## GEORGE HALL MPR AND SUPPORT ROOMS PROJECT #19-143

### ADDENDUM NO. 3

**Date:** November 24, 2021

6 ARTIFICIAL TURF DETAIL

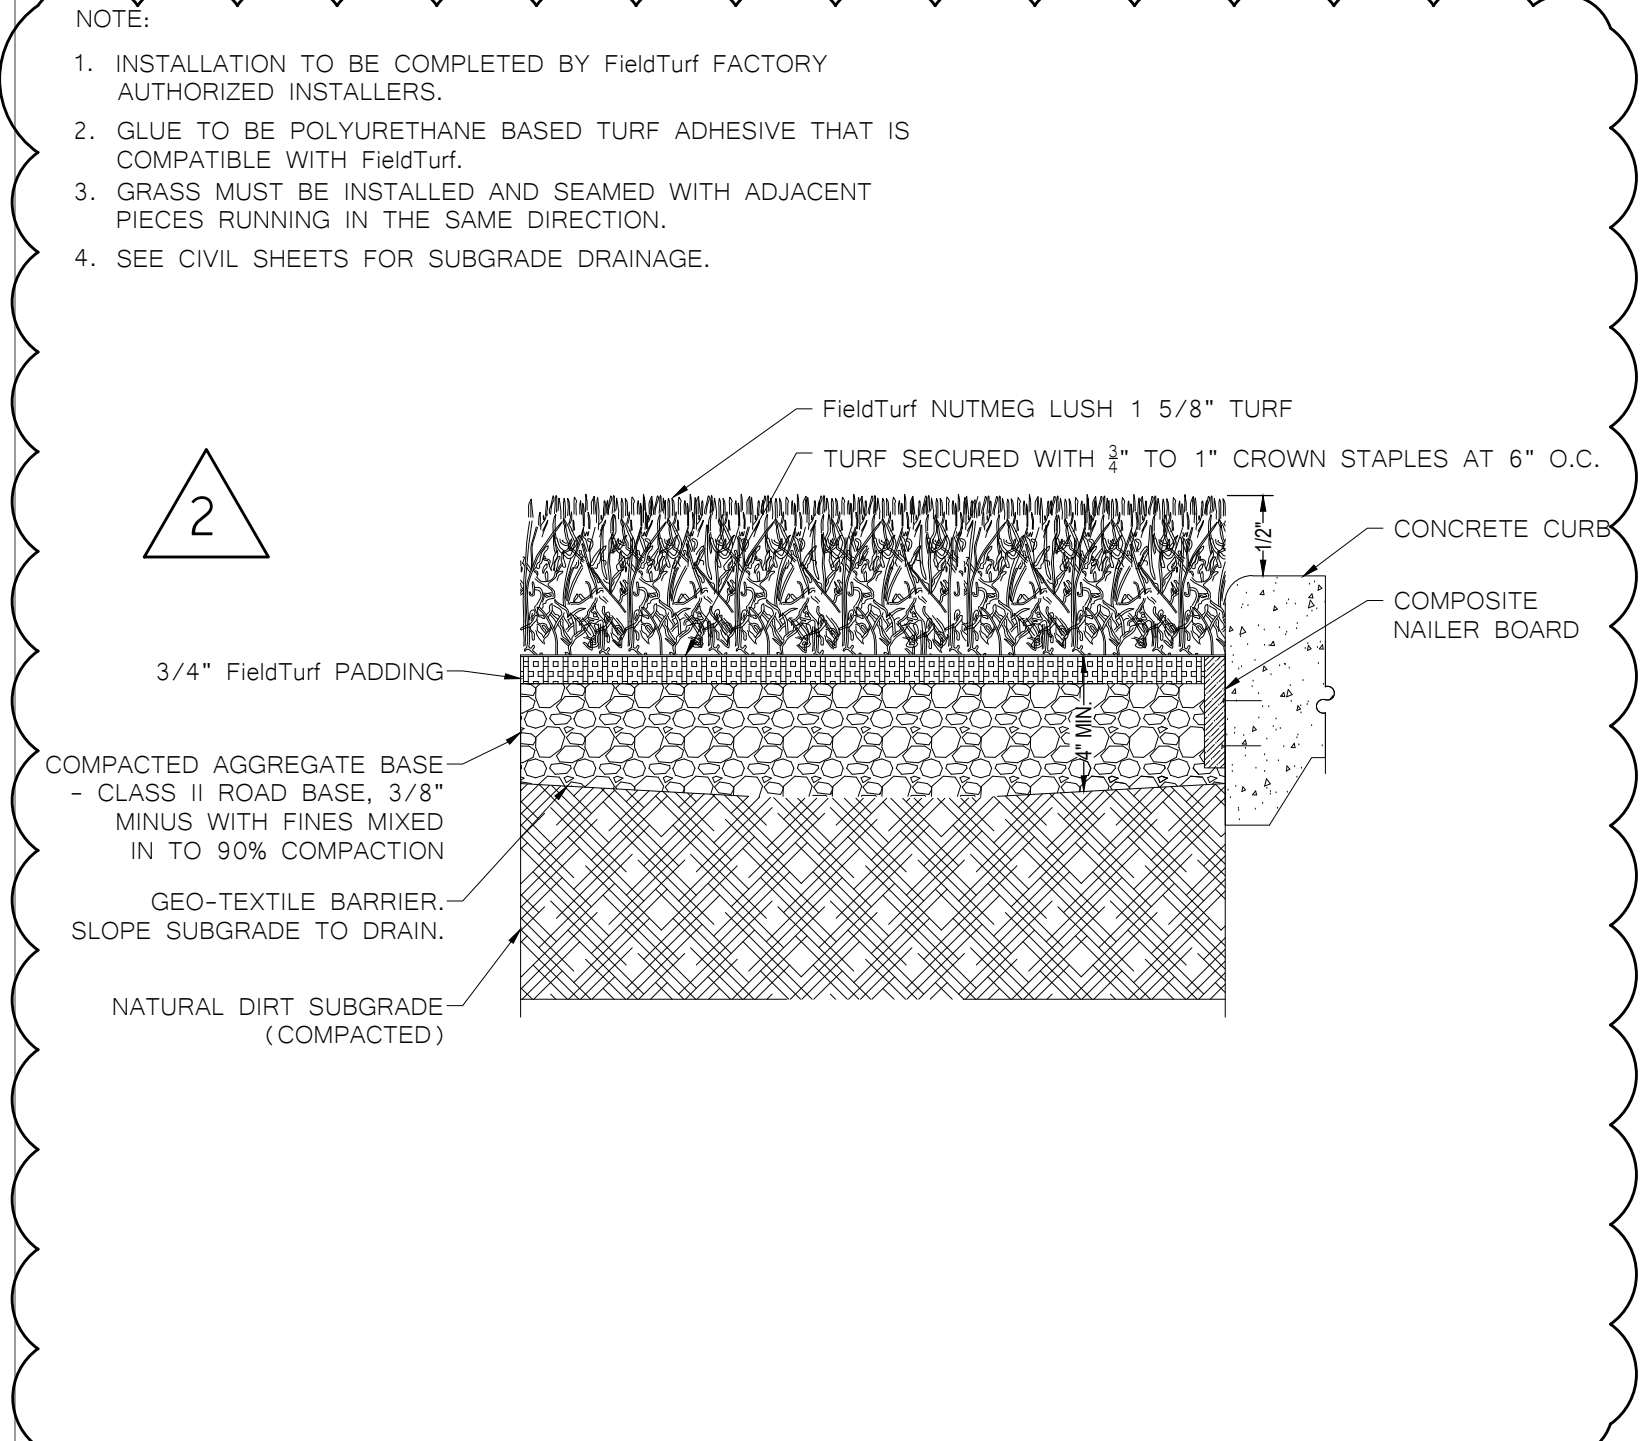
4. **Q:** PRE-BID RFI 11 – Turf pad thickness?  
**A:** See attached **PRE-BID RFI 11 response and detail 6/L4.2 re-issued.**
5. **Q:** PRE-BID RFI 16 – Sun shade devices 08 41 13 - 2.05?

6. **SHEET ‘L4.21 LANDSCAPE CONSTRUCTION AND PLANTING DETAILS’**

A. Detail 6 Artificial Turf Detail – Revise notes to clarify and specify Turf components

**QUESTION :**  
**Can you confirm the thickness of pad below the artificial turf?**

**Pad thickness to be 3/4" inch with Field Turf Nutmeg Lush 1 5/8" turf with Anti-microbial silica sand fill.**
